Product Safety Recall

N212340980 Rear Toe Link Separation

Release Date: January 2022 **Revision:** 04
Revision Description: The service procedure Alignment Settings has been updated in this bulletin. Please discard all previous copies of N212340980.

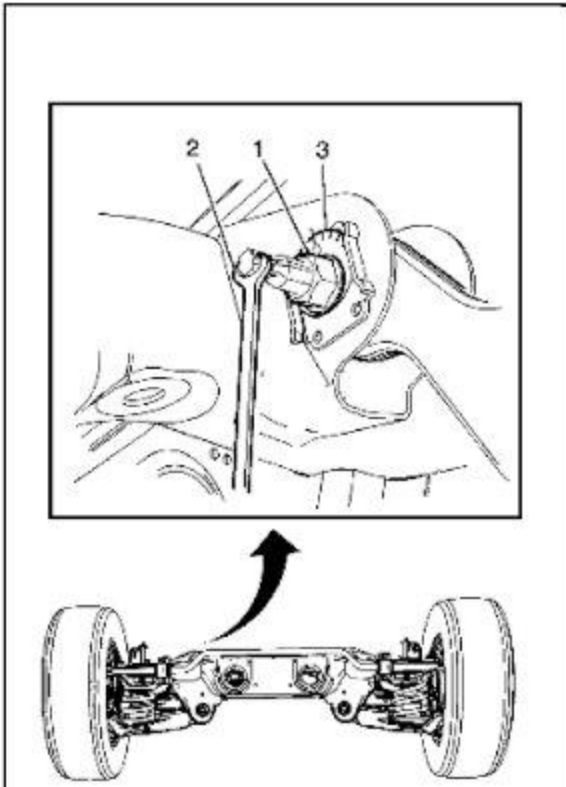
NOTE: If there are any illegible digits on the serial number, place an "x" in its place.

2. If installing the over-mold part, record the serial numbers from BOTH new suspension links on the job card (not required for the solid link service part).
